Beech Street Center

Town of Belmont ADA Transition Plan

October 2020

Institute for Human Centered Design

Figure 1: Suggested location for 48” wide min. accessible concrete path connecting the patio to the bocce ball court and to at least one bench in this area.

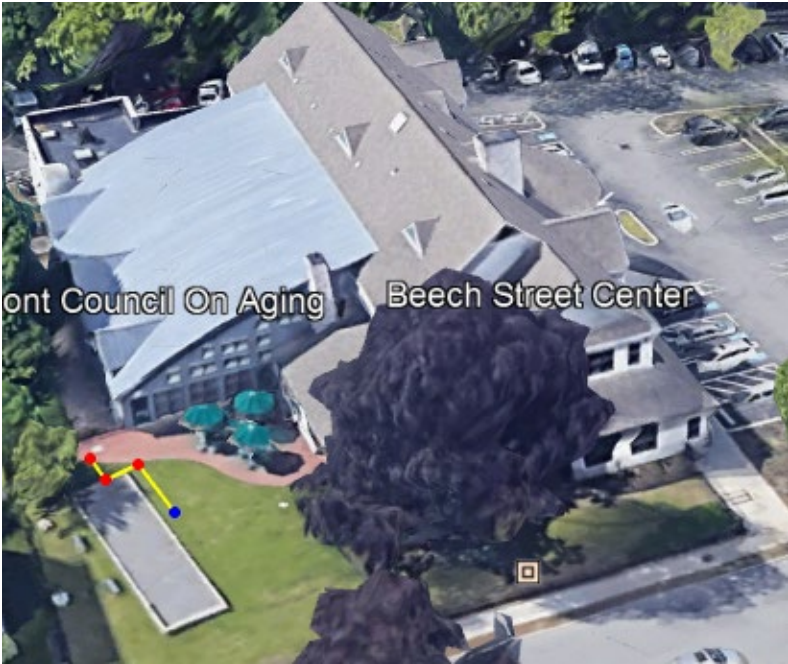
Accessibility issues with exterior access routes include excessive changes in level and an excessive cross slope. There is also lack of an accessible route from the patio to the bocce ball court, to at least one bench in the bocce ball court area, and to the exterior book exchange receptacle on Beech Street.

Exterior Benches												
29	Patio on East Side of Building	Ext.		Exterior Benches	N/A		No accessible route to one bench in area Accessible route not provided	-	Relocate at least one bench in this area to an accessible route and provide an accessible route from the patio connecting to the bocce ball court and to at least one bench of the north side of the bocce court.) (Cost based on a 4' wide x 30' long concrete path with a max. running slope of 1:20 (5.00%) and a max. cross slope of 1:50 (2.00%) as shown in Figure 1 of the narrative.)	1	1920	\$1920
Toilet & Bathing Rooms
